**HISTORIC PRESERVATION
BOARD**

Case No. H18-03

100 Public Square

Case No: H18-03
Address: 100 Public Square
Applicant: Mike Bizjak – Cicogna Electric & Sign
Subject: Conditional sign approval – Ohio Real Title
Zoning: C-2 – Central Business District
Submitted by: Jonathan Mendel, Community Development Director

WALL SIGN

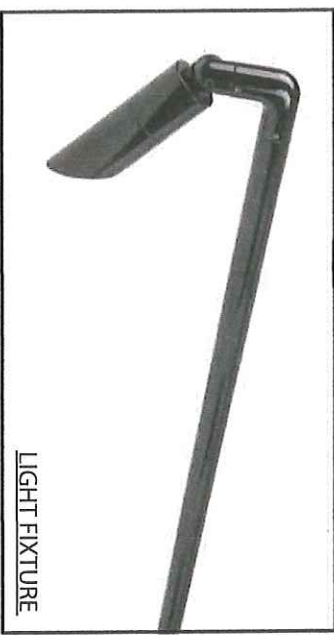
The wall sign is 6.25 sqft and the maximum allowed is 28 square feet.

BLADE SIGN

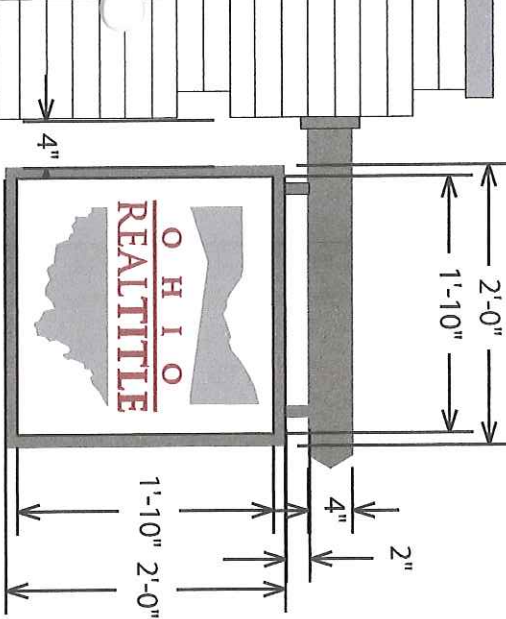
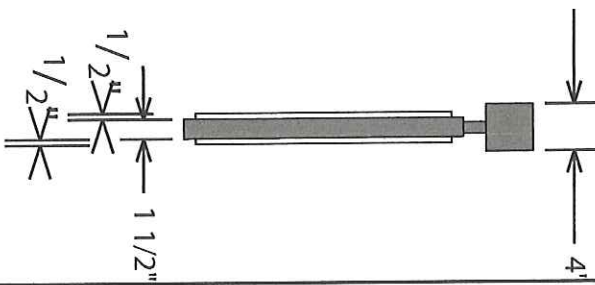
The projecting sign is 3.4 sqft and the maximum allowed is 4 sqft. Section 1147.15(e) states that projecting signs shall be located not more than 14 feet above finished grade as measured from top of sign, and shall maintain a minimum vertical clearance of 8 feet from bottom of sign to finished grade. The proposed projecting sign appears to comply and will be verified as part of the permitting process.

POST SIGN

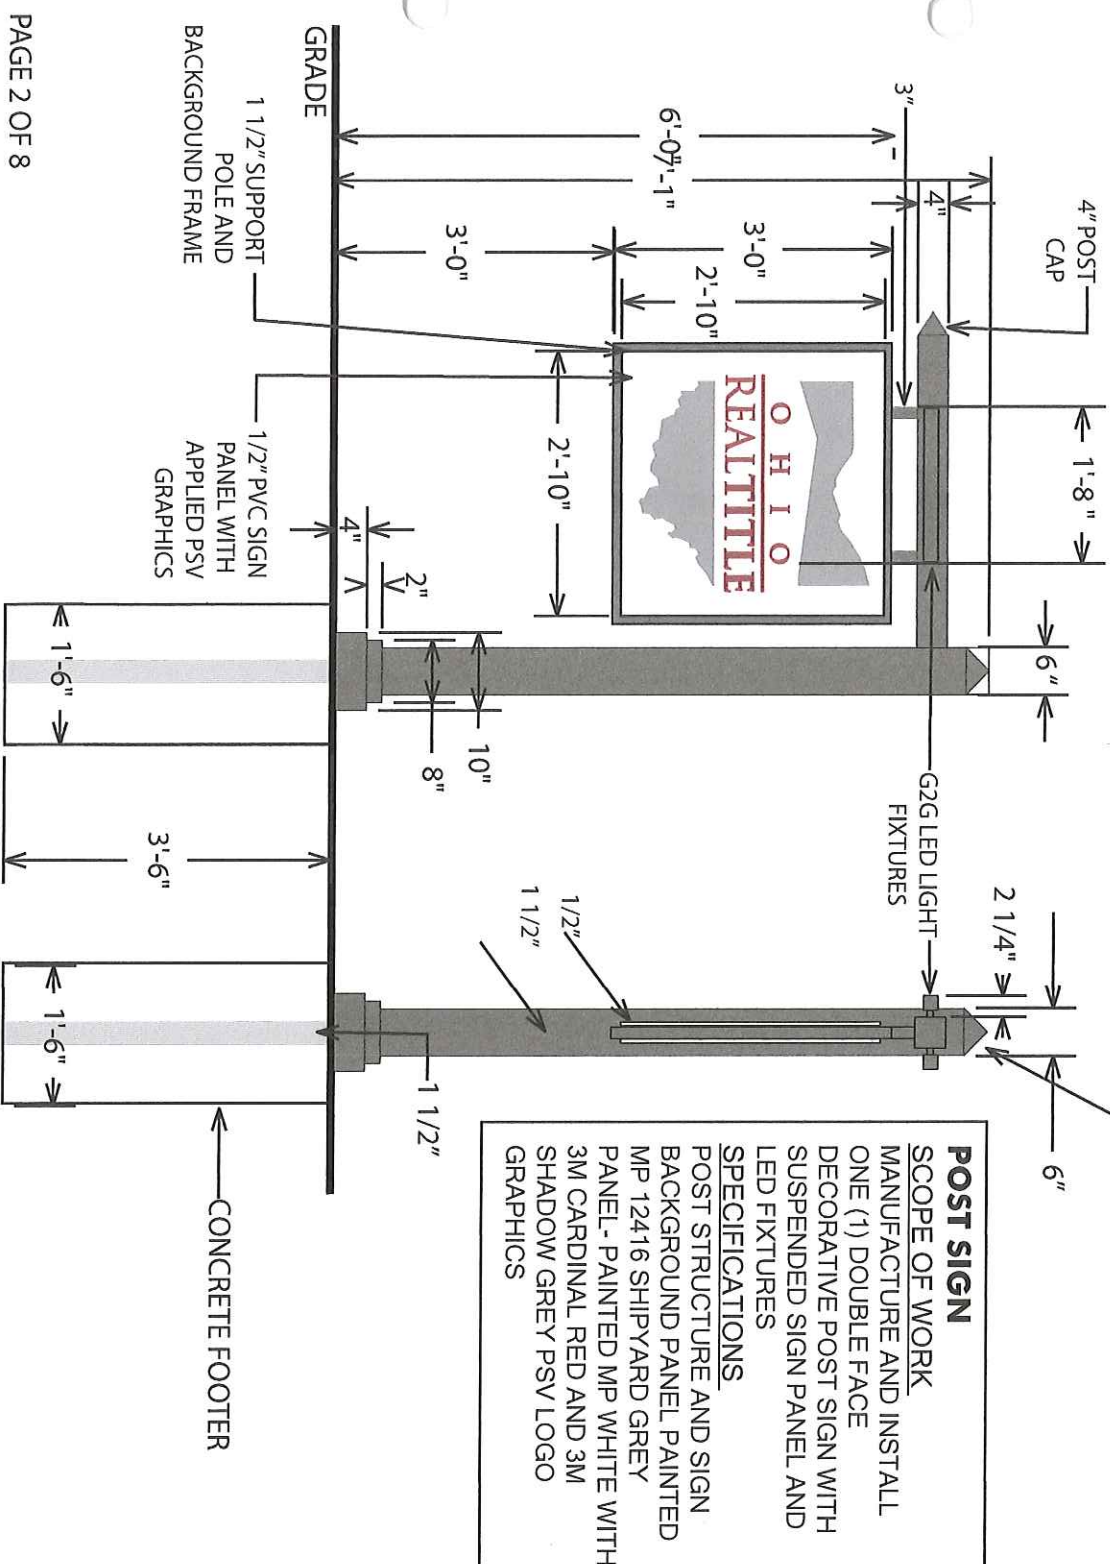
There is also a ground sign proposed in front of the subject site along the N. Broadway frontage. This sign will not be approved by the Historic Preservation Board. It must be reviewed and approved by the City Council through a revocable use permit process, because the proposed ground sign is within the N. Broadway public-right-of-way. For that process, the City Council will likely want HPB comments on the sign as if it was being reviewed by the HPB through the typical conditional sign approval process.

Note: If the applicant wishes to request a revocable use permit for the proposed ground sign from the City Council, it would assist that process if the HPB could provide comments regarding the design and appropriateness of the proposed sign for the benefit of the City Council.

Staff recommends the Historic Preservation Board grant a conditional sign approval for the proposed signs, except the proposed ground sign.
